SUBJECT: ISSUANCE OF AMENDMENT (TAC NO. 67743)

The Commission has issued the enclosed Amendment No. 129 to Provisional Operating License No. DPR-16 for the Oyster Creek Nuclear Generating Station, in response to your application dated March 30, 1988, as supplemented April 12, 1988 and September 22, 1988.

The amendment modifies Section 3.10 of the Technical Specifications to accommodate the Cycle 12 Core Reload. Specifically, the Minimum Critical Power Ratio (MCPR) and the maximum average planar linear heat generator rated (MAPLHGR) limit is changed. It also permits the use of GE8x8EB fuel.

ATTACHMENT TO LICENSE AMENDMENT NO. 129

FIGURE 3.10-4

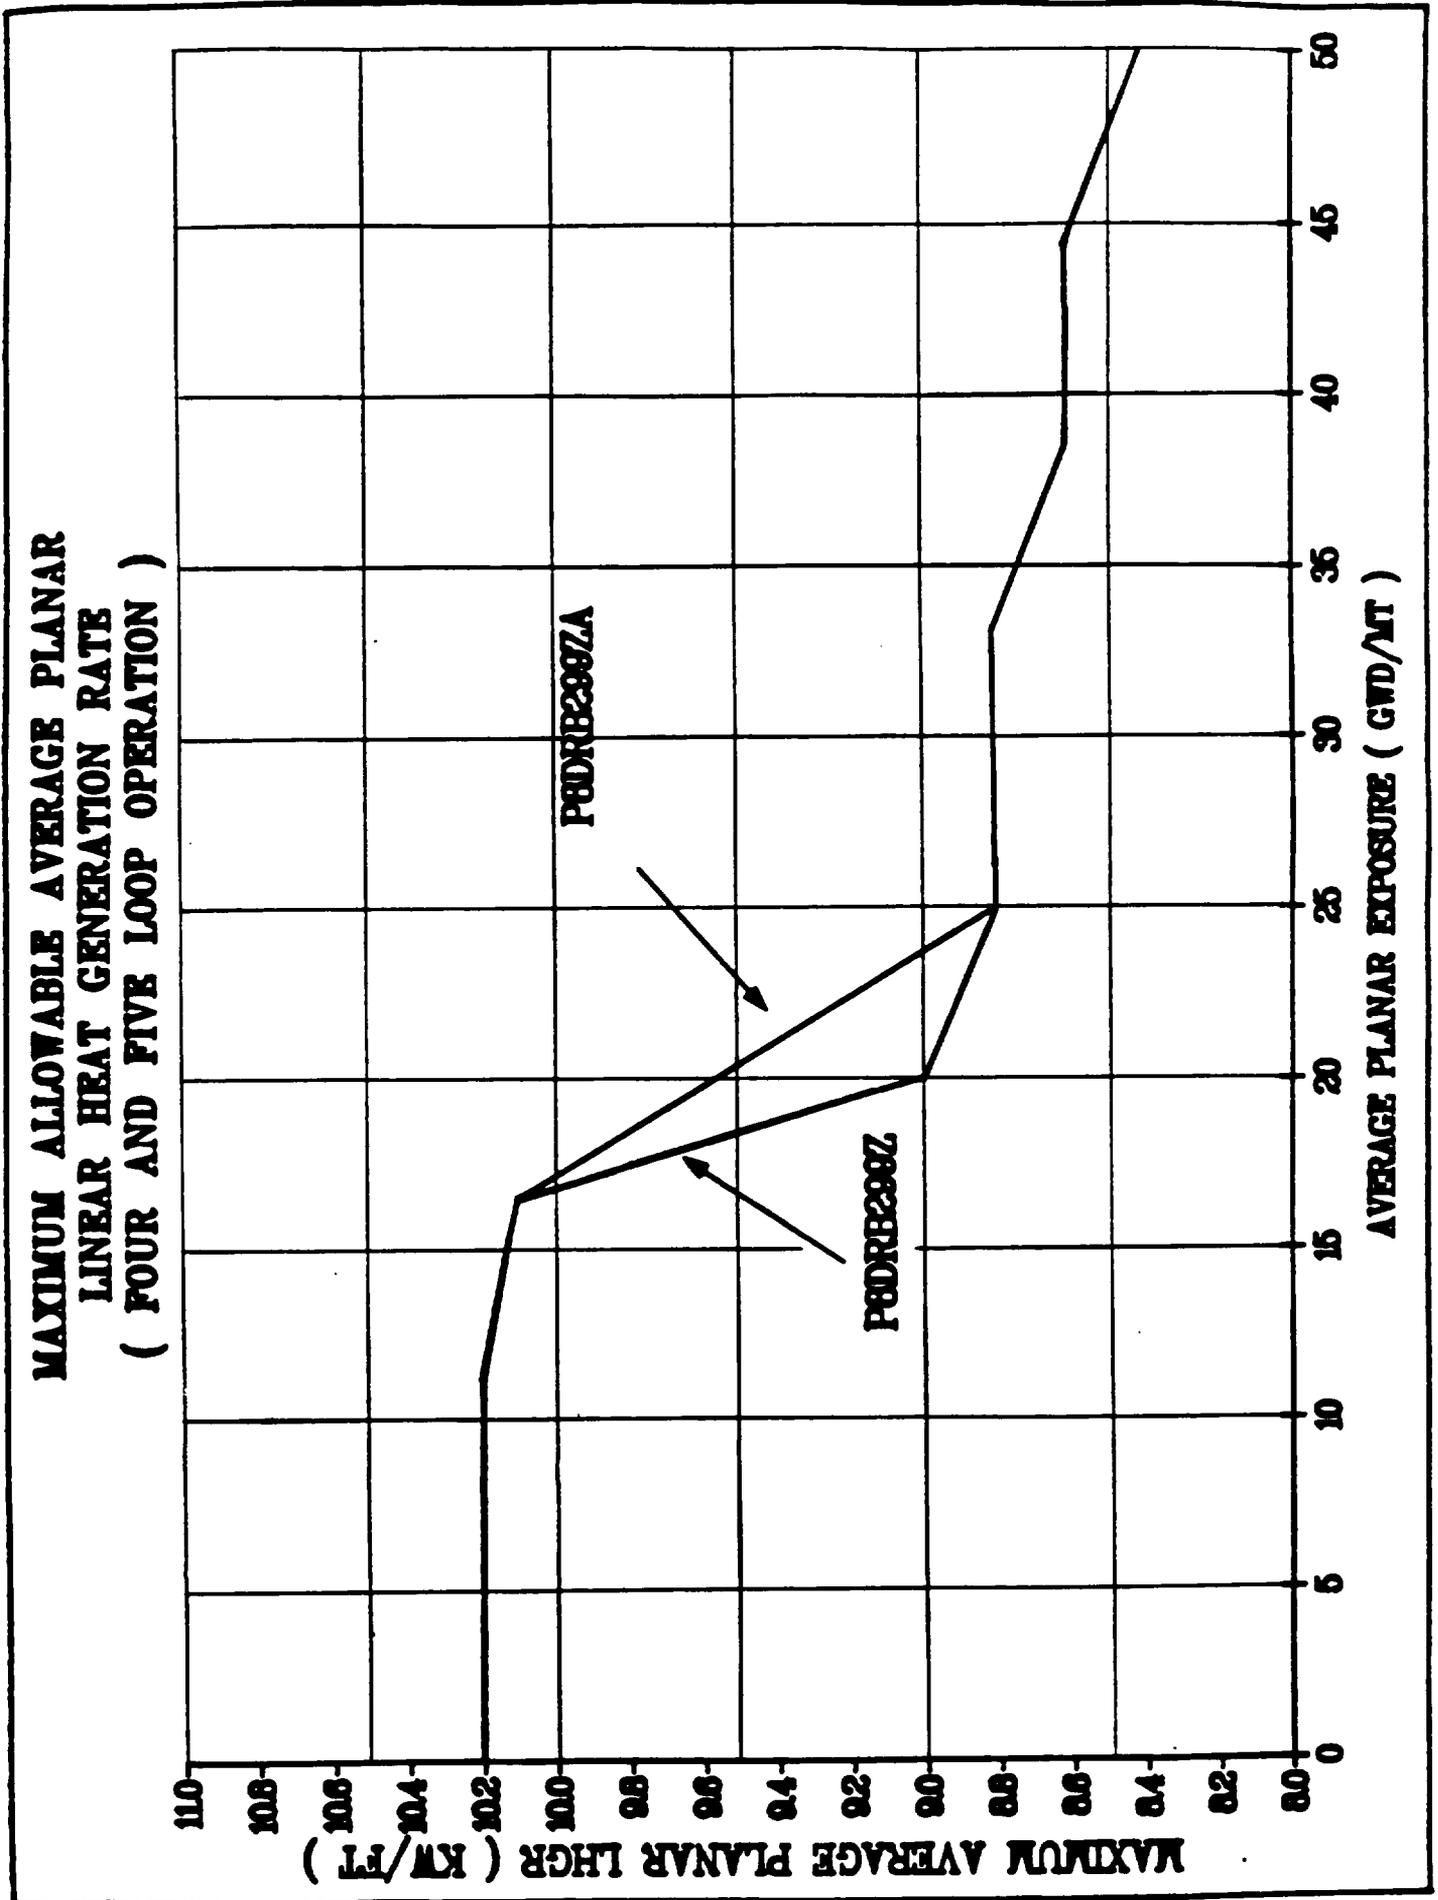
The maximum average planar LHGR (MAPLHGR) limit shown in Figure 3.10-4 and 3.10-5 for both 5-loop and 4-loop operation.

The maximum average planar LHGR limits of fuel types P8x8R and GE8x8EB are shown in Figure 3.10-4 and Figure 3.10-5, for both 5-loop and 4-loop operation, and are based on calculations employing the models described in Reference 4. Power operation with LHGR's at or below those shown in Figures 3.10-4 and 3.10-5 assures that the peak cladding temperature following a postulated loss-of-coolant accident will not exceed the 2200°F limit.

1. Section 3.10.A: Add new limits for GE8x8EB fuel and revise limits for P8x8R fuel design. The new and revised MAPLHGR will be applied to both four loop (with the inactive loop suction and discharged valves unisolated) and five loop operation.
2. Section 3.10.B: Add reference for new fuel design (GE8x8EB) to include LHGR limit of equal to or less than 13.4 kw/ft.
3. Section 3.10.C: Change operating limits MCPR from 1.45 to 1.51 for each of the three APRM status levels.
